Date: July 12, 2018  
To: Cumberland Planning Board  
From: Carla Nixon, Town Planner  
Subject: Site Plan Review: ReVision Energy Solar Array

Date July 12, 2018  
To Town of Cumberland Planning Board  
From Carla Nixon, Town Planner  
Subject **Major Site Plan–Revision Energy Solar Array – Drowne Road**

Subject: 474.7 kW Solar Array  
Town of Cumberland Site Plan Review Application  
Response to Peer Review Comments dated 7/10/18

SITE PLAN

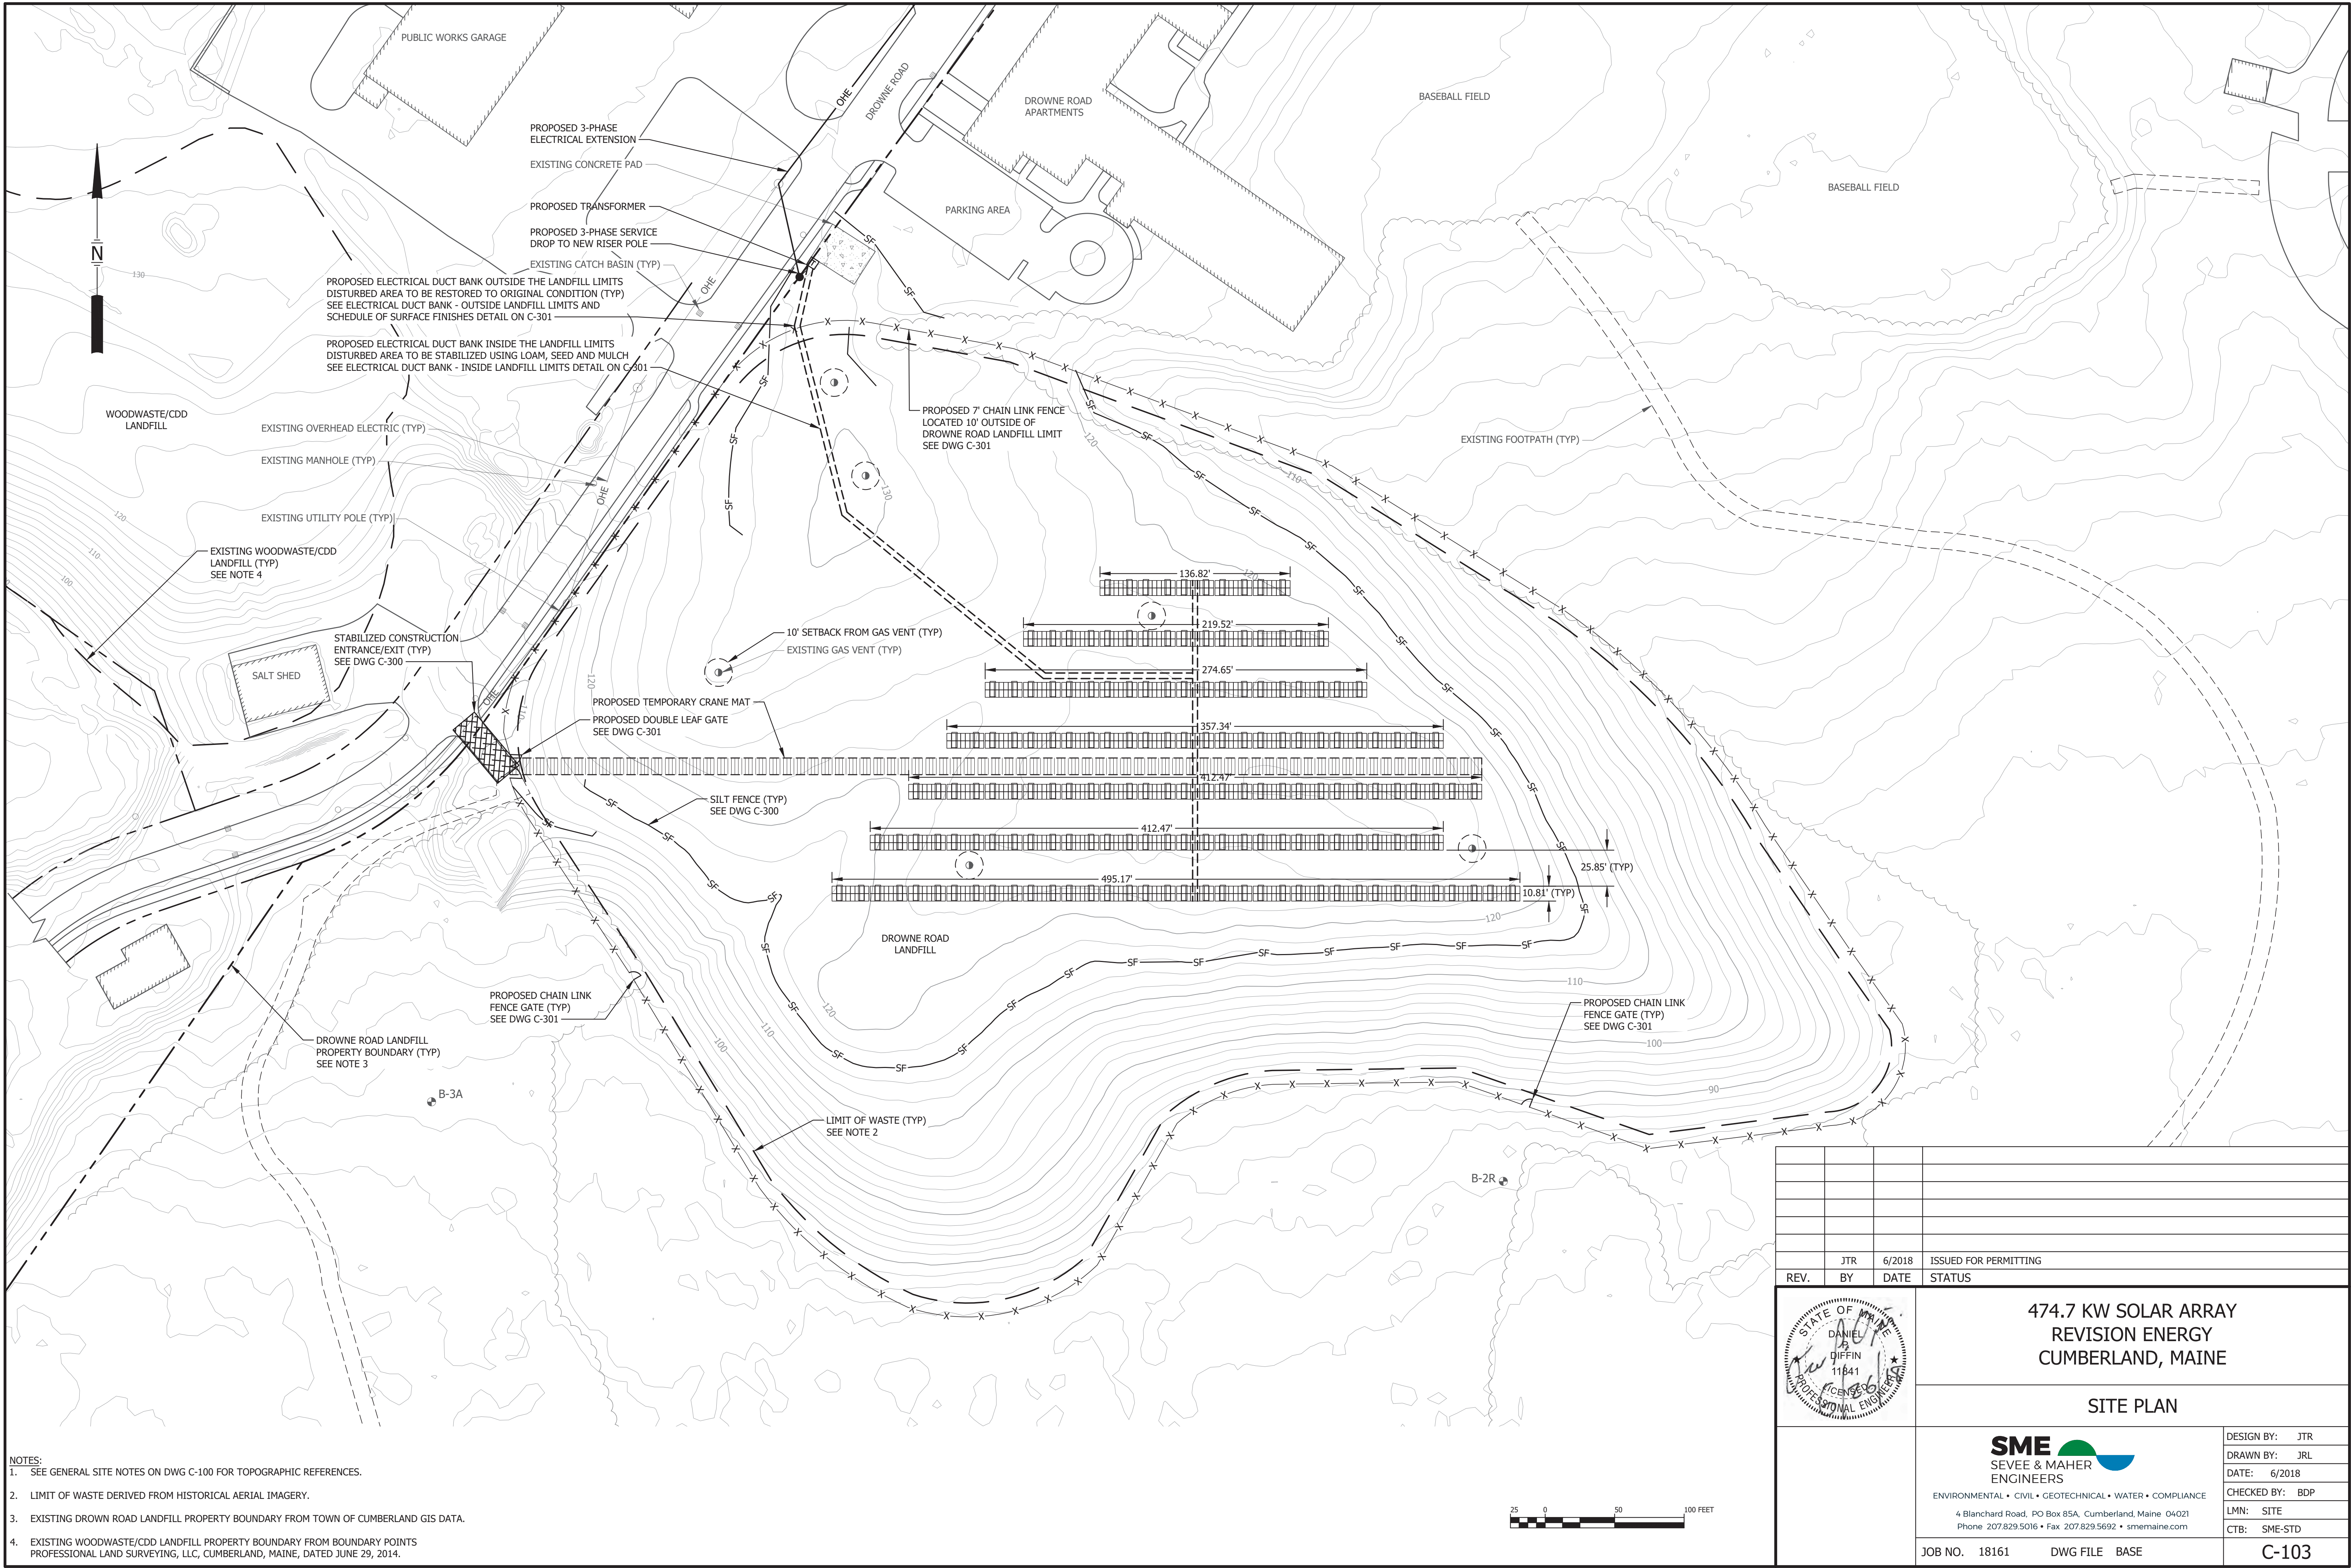
- Site Plan
  - What horizontal control will be provided to ensure that the proposed fence will be installed outside the Limit of Waste?
  - Will the "temporary crane mat" be used for all material deliveries including the crushed stone, footer block supports, racks and panels?
  - The slope of the "temporary crane mat" access is approximately 12% approaching Drowne Road? Is this the optimum access point given the slope constraints?
  - Based on observations at other facilities, it appears that construction vehicle access is necessary between successive rows of panels to allow construction, which may result in a greater disturbed area than proposed as part of the application. We would recommend that the Applicant clearly depict the limits of disturbance on the Site Plan to ensure that they are not exceeded during

- The plan depicts installation of silt fence within the limit of the landfill which would result in the stakes penetrating 6" into the 18" clay cap. Is this desirable?

for the site using the Online Positioning User Service (OPUS), and provide survey layout for critical points of the proposed work.

SME's Response: Erosion control mix sediment barrier will be used within the limits of waste to minimize disturbance to the existing clay cap.
